**ITEM 7. DEVELOPMENT APPLICATION: 301-303 BOTANY ROAD ZETLAND****FILE NO: D/2014/1758****DEVELOPMENT APPLICATION NO: D/2014/1758****SUMMARY****Date of Submission:** 13 November 2014**Applicant:** Crown Green Square Developments Pty Ltd**Architect:** Koichi Takada Architects**Developer:** Crown Green Square Developments Pty Ltd**Owners:** Crown Green Square Pty Ltd, Sathio Investments Pty Ltd and Crown Cornerstone Investments Pty Ltd**Cost of Works:** \$177,100,000

**Proposal Summary:** Stage 2 Development Application for the construction of a mixed use development. The proposal comprises the construction of a part 8 and part 20 storey mixed use building above 3 basement car parking levels. The proposed uses of the building include 401 apartments; retail tenancies along Botany Road, Bourke Street, future Tweed Place, future Ebsworth Street and future Green Square Plaza; a multi-purpose function facility and car parking for 403 vehicles. The proposal also includes a through-site link from Ebsworth Street to the Green Square Plaza and site landscaping. Vehicle access is proposed to and from future Tweed Place.

**Figure 12:** Extract from Green Square DCP showing building height control in storeys

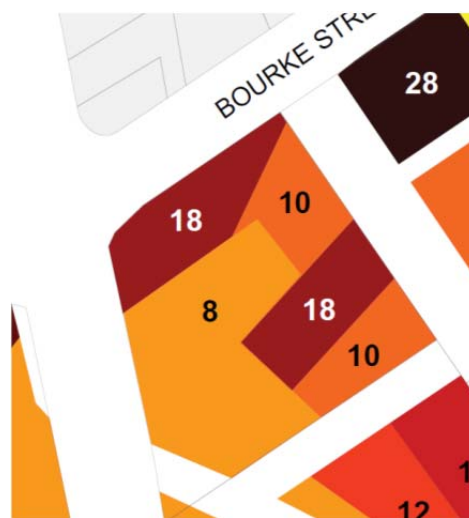
86. The proposal is non-compliant with the number of storeys specified in the GSTC DCP and the maximum building height within the GSTC LEP. A compliant scheme under the GSTC DCP would have a height up to 18 storeys, but in a particular arrangement of 2 x 18 storey towers above 8-10 storey podium elements (see **Figure 12**). A compliant scheme under the GSTC LEP would have a maximum height of RL 79.5.
87. The proposal is also non-compliant with the GSTC DCP in relation to providing, along Ebsworth Street only, an 8 storey "street wall" frontage and a 3m secondary setback to create a recessive upper element. However, the GSTC DCP would allow an 18 storey tower without a street wall for part of the Ebsworth Street frontage.

89. The maximum building height generally complies with the GSTC LEP. There is a protrusion above the maximum height by 0.5m for a rooftop skylight with ventilating windows for the top floor apartments. The non-complying portion is not visible from the public domain and is a minor exceedance. The Applicant has lodged a request under Clause 4.6 of the GSTC LEP to waive strict compliance with the height standard and their request is justified and acceptable.

90. The non-compliances with the height in storeys and street wall height are justified and acceptable.

**Figure 13:** Balustrade glass panels with frit patterning – three typical panels above and a row of panels below

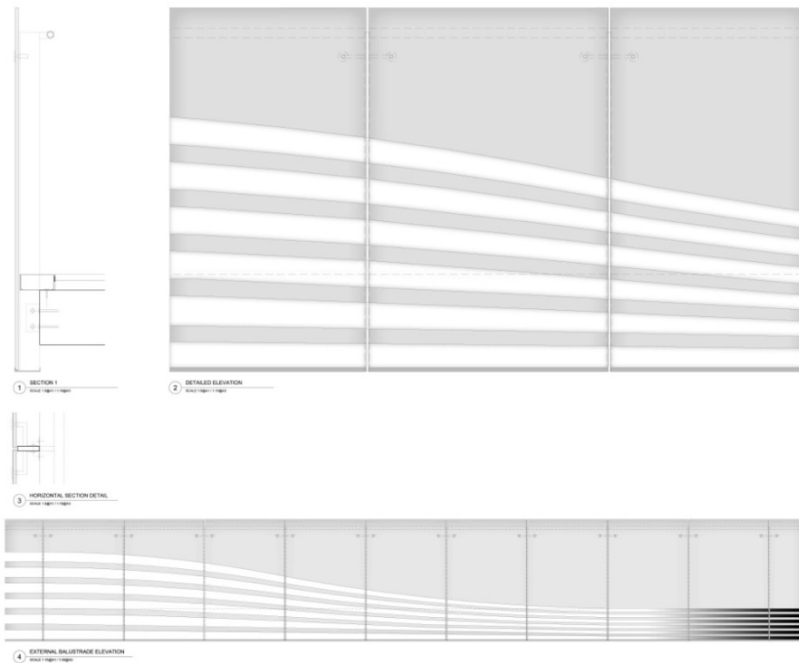
91. The proposal incorporates a generally glazed facade with curved glazed balustrading concealing the concrete slab edges. The balustrade is a clear feature of the proposal. The glass is semi-frameless with an undulating fritted pattern defining the form of the proposal and providing visual privacy to habitable rooms where required. The balustrade design is shown in the following images. The glazing has a permanent 400mm high base pattern that covers the slab edge. The pattern undulates in height up to 1100mm:

**Figure 14:** Extract from elevation and section showing balustrade patterning and fixing methodology

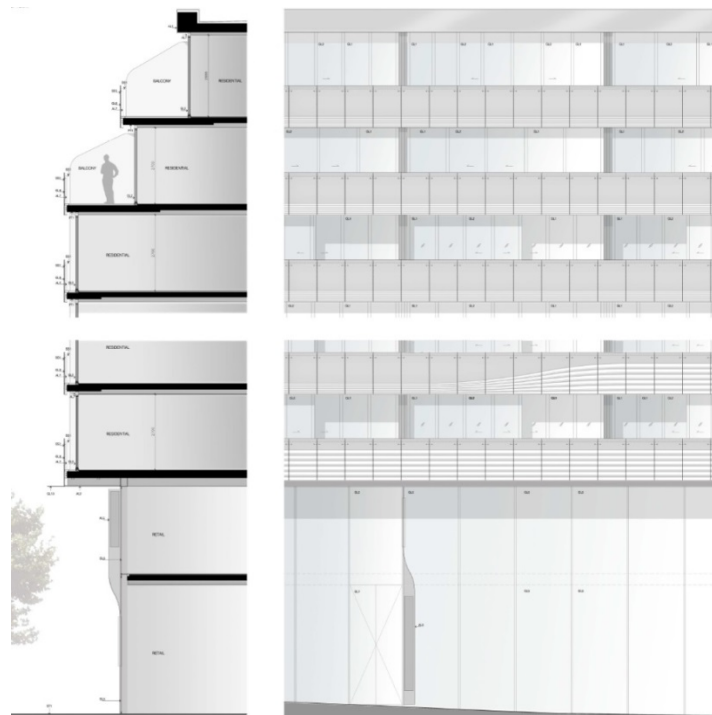
92. The City's Design Advisory Panel and Council Officers believe that the aesthetic success of the project relies heavily on its ability to maintain the quality of the curved, patterned facade edge from design competition concept through to completion. The Applicant estimates that the balustrading component of the development alone is valued at over \$10million. The Applicant has given undertakings that the facade will not be value-engineered to reduce construction costs. However, a final review of finishes is desirable as part of conditions of consent.
93. To ensure the development maintains design excellence through-out the construction documentation phase, the draft conditions of consent include a requirement for the Applicant to submit final details of materials and finishes for the approval of Council's Director, City Planning, Development and Transport.
